UN/ECE/WP29/GRSP Pedestrian Safety gtr Informal Group 2nd Interim Report

PEDESTRIAN PROTECTION.

This document is a working document circulated for discussion and comments. It is only submitted with the intention to facilitate discussion by the GRSP Informal Group.

GLOBAL TECHNICAL REGULATION NO. Y

Figure 13: Windscreen test area.

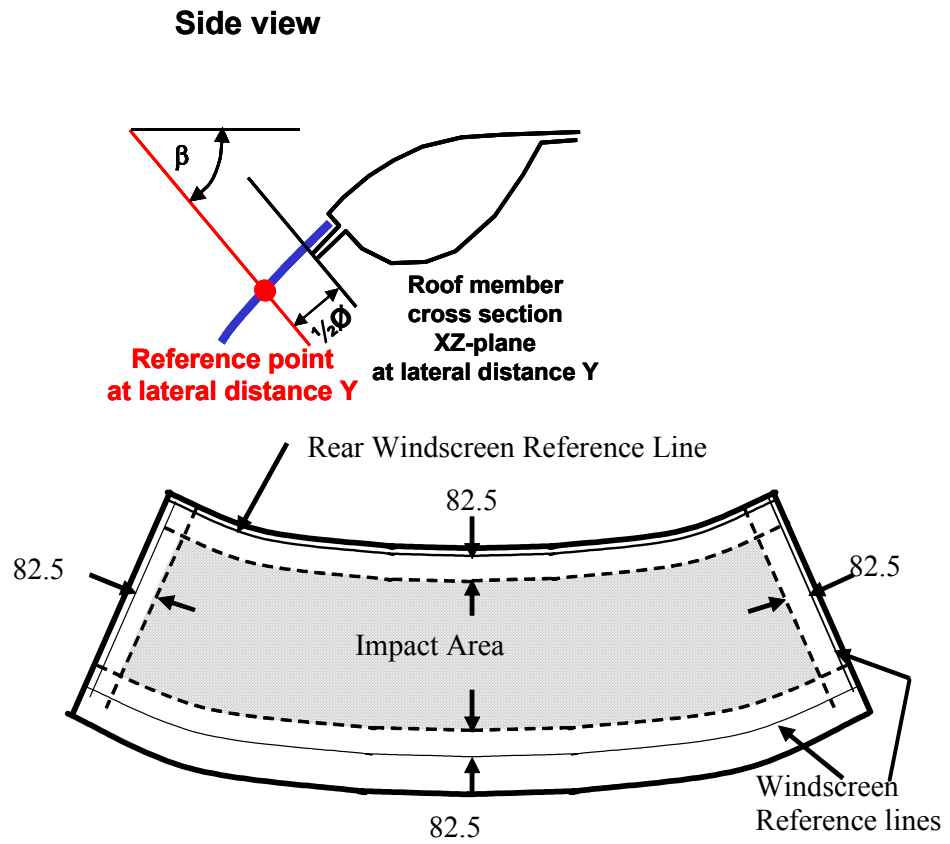
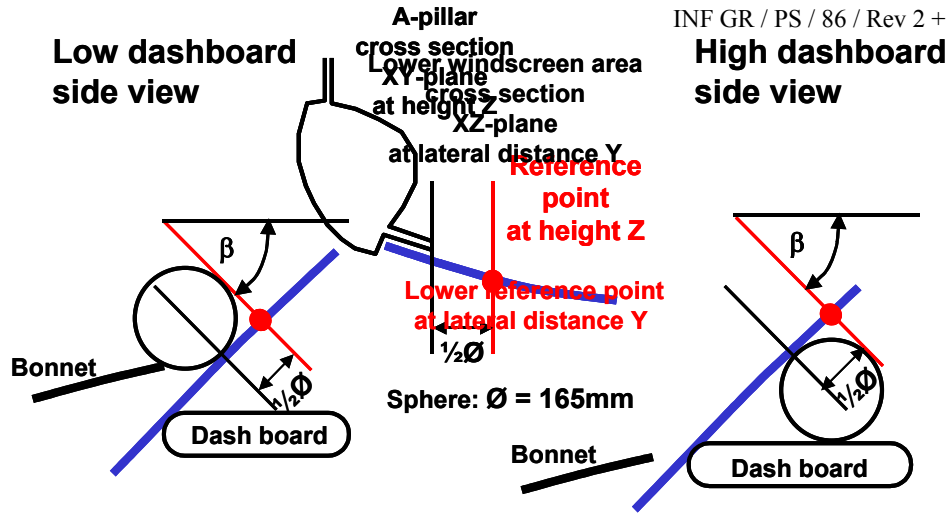
EU Comment: This diagram requires more discussion and agreement.

[EU Comment: This diagram requires more discussion and agreement.](#)

[EU Comment: This diagram requires more discussion and agreement.](#)
